City of Biddeford
Planning Board
September 29, 2021 6:00 PM City Hall
Council Chambers, & via ZOOM
Sep 29, 2021 06:00 PM Eastern Time (US and Canada)
Topic: Planning Board

- 7.D. Final Site Plan/Subdivision Review and a Public Hearing and make a recommendation to the City Council regarding a proposed Contract Zone for Adams Point, LP and Southern Maine Affordable Housing at 69 Adam's Street (Tax Map 38, Lot 296) to allow for 39 units of multi-family housing in a structure not to exceed 60 feet in height (5 stories) as measured from grade to the highest roof beams of a flat roof, excluding any parapets for elevators, roof access, or the screening of mechanical equipment, and to provide less than 1 parking spaces per unit. Multi-family housing is a permitted use in the underlying zone (MSRD-2).

[4.0 Board Report - Adams Point Final Plan-rv \(929 MTG\).pdf](#)

SHEET: 4 OF 22

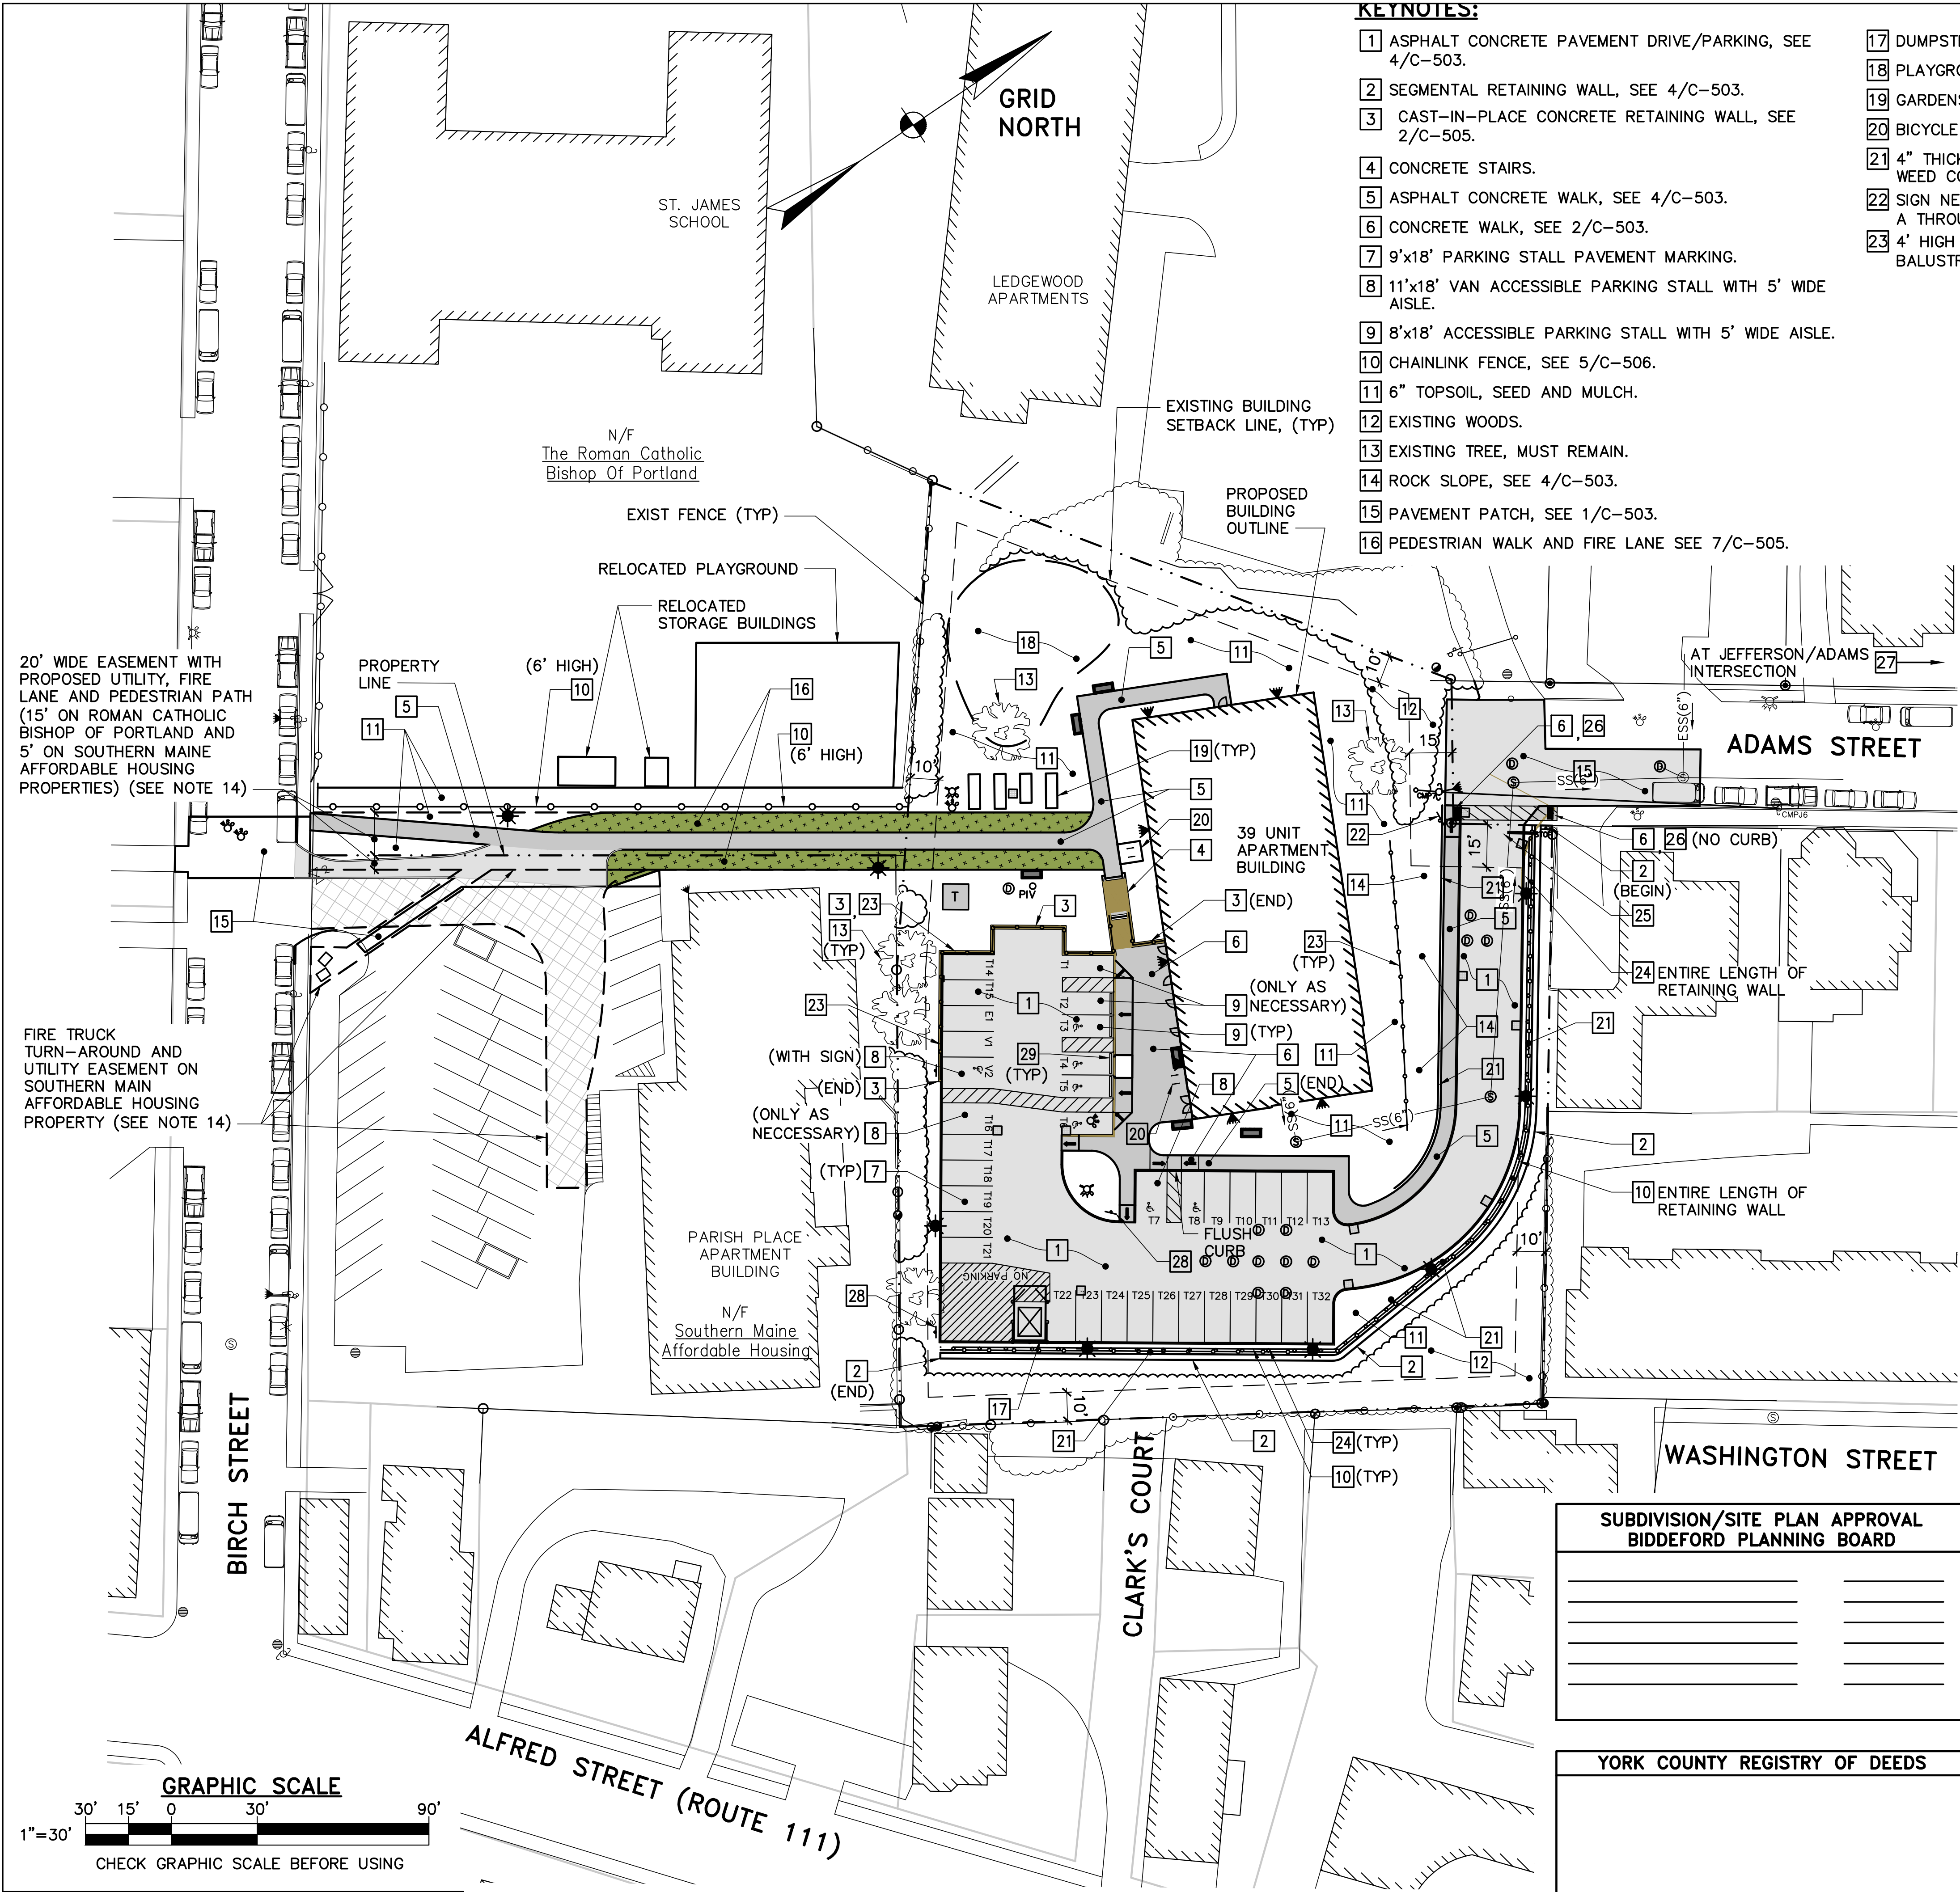
1. Sheet 4 of 19 (now 4 of 22) – Site Plan

- k. What is planned for curbing material within the parking lot? The response indicated that notes were added to clarify the intent for curb, but we were unable to verify that. **Response: Keynote 1 on drawing CS101 refers to detail 4 on drawing C-503. Detail 4 calls out the concrete curb types on either side of the driveway. The title of the detail will be revised to state "TYPICAL DRIVEWAY/PARKING AREA/WALK/RETAINING WALL SECTION".**

- l. (New) No van accessible spaces are provided on the site. A minimum of one is necessary to meet ADA requirements. **Response: Keynote 8 on drawing CS101 indicates 11'x18' van accessible parking with a 5' access aisle. Parking space T7 will be expanded 3' to be a van accessible.**

- 3. In addition, a sign should be considered at the entrance drive that, along with identification of the address, state that this not a through way and the public street ends here. **Response: This has been addressed on drawing CS101, Keynote 22.**

16. The slope created between the northerly side of the building and the driveway, looks to be close to a 1:1 slope. The applicant has explained that a rock slope (existing ledge) is planned in this area and measures will be taken with regard to safety of residents negotiating through the property. **Response: This is addressed using a fence at the top of the slope to prevent direct access to the slope (see drawing CS101).**

SCALE: AS NOTED
DATE: 08-02-2021
DWG.: C-503
SHEET: 12 OF 22

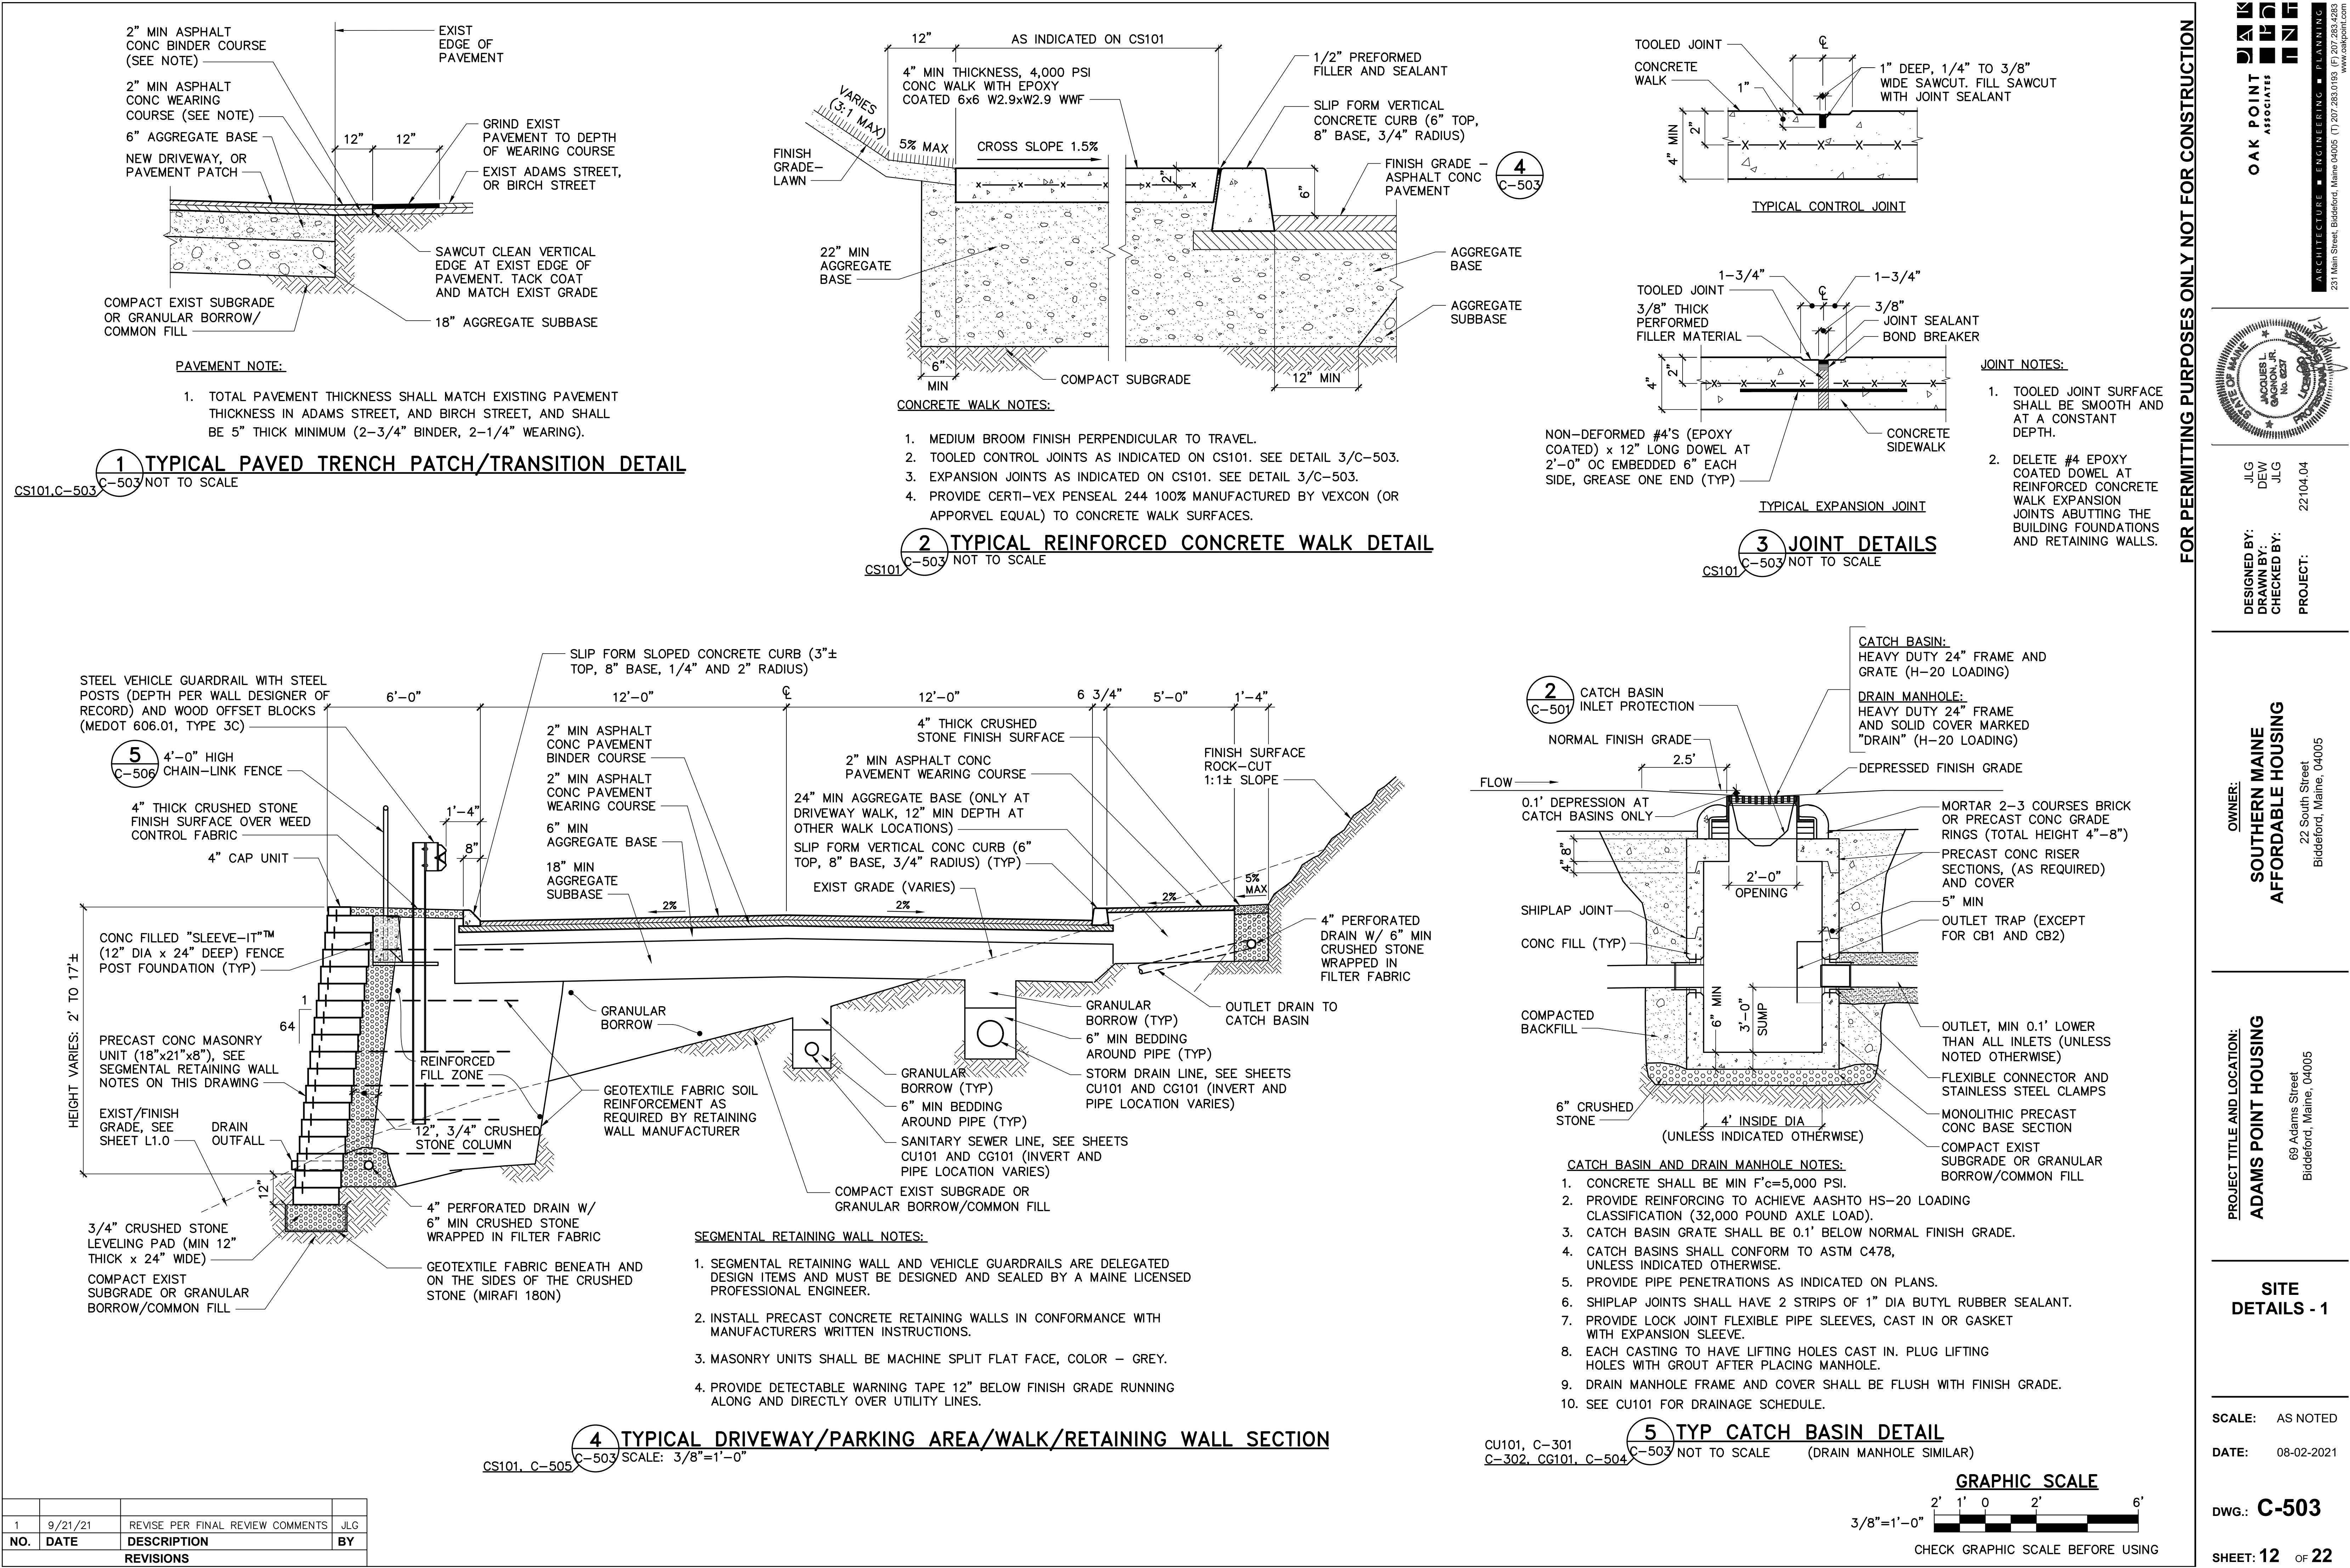
- Sheet C-503

- o Detail 4 – connection locations for sidewalk underdrain and retaining wall underdrain should be identified. **Response: Underdrain connections have been added.**
